DP20-0007 & DVP20-0008 66o Cawston Ave.

Development Permit &
Development Variance Permit Application

Variance 1

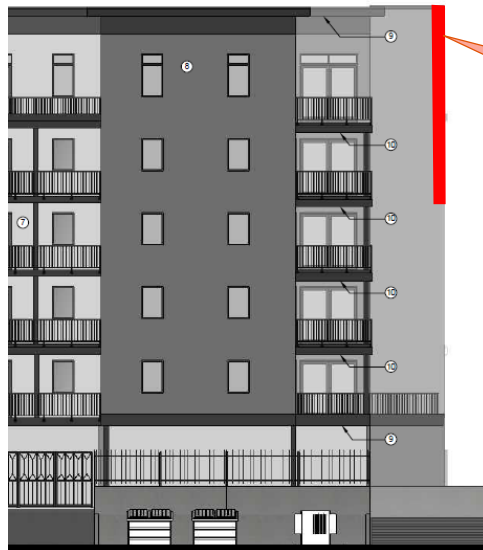
- ▶ Reduce side yard setback above 16m from 4m required to 3.8m for stairwell shaft on west side.
 - ▶ Variance is minor in extent and includes only a small portion of the building.

Variance 2

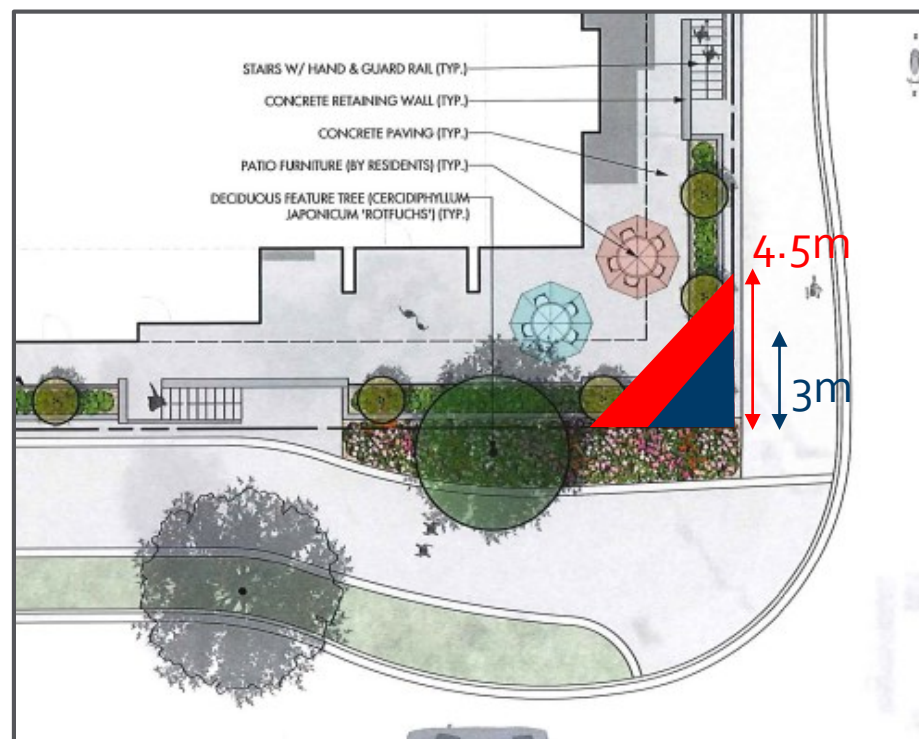
- ▶ Reduce triangular setback on 1st storey at intersection from 4.5m required to 3m.
- ▶ 4.5m setback intended primarily for mixed-use buildings in heart of the downtown core where pedestrian traffic is at its highest, and where an extended corner cut is thought to be beneficial to provide people a place to congregate
